12 Elevations and Materials: Amendment Response

DESIGN AND ACCESS STATEMENT ADDENDUM

Application Ref: 2014/6845/P

Pears Building Pond Street London

Fig 37 Proposed Amendment - Elevations and Materials

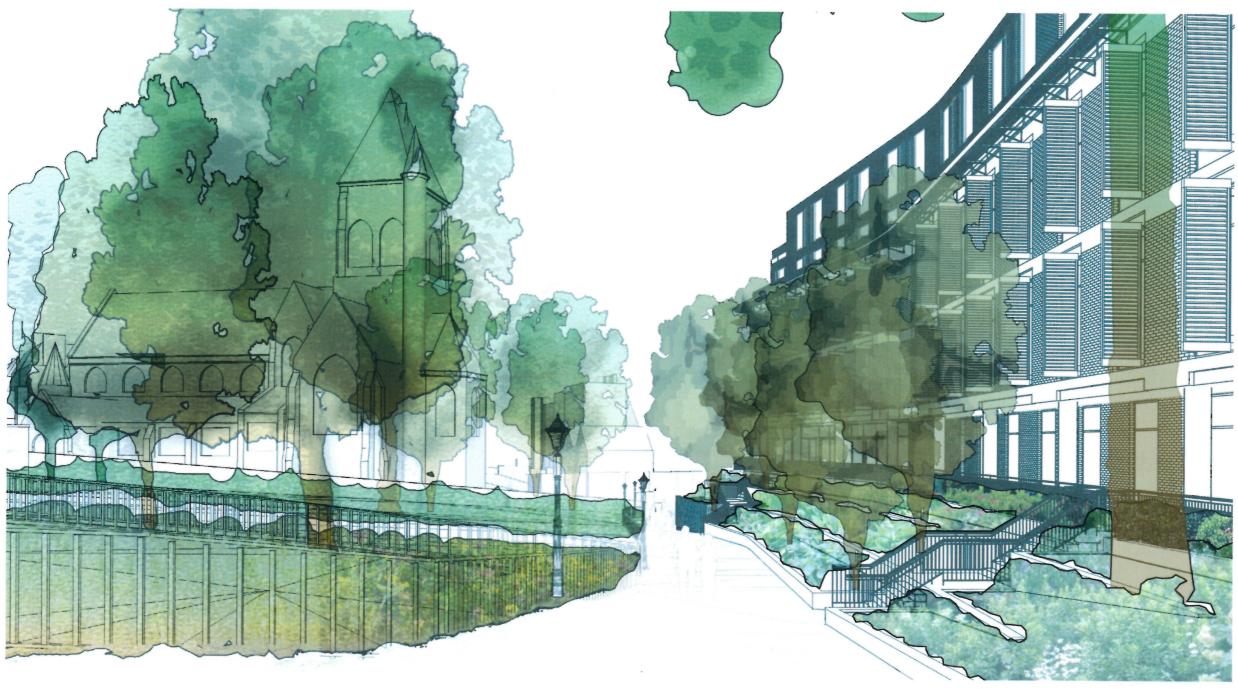
The amended perspective shows the following:

- 1. The revised width of the public footpath (to return as close as possible to its existing footprint).
- 2. Revised stairs along the West elevations changes to stairs required to accommodate the reduced width of the proposed landscape.
- 3. Revised width of the landscaped external terraces widths changed locally to allow for the evised width of the public footpath (to return as close as possible to its existing footprint).
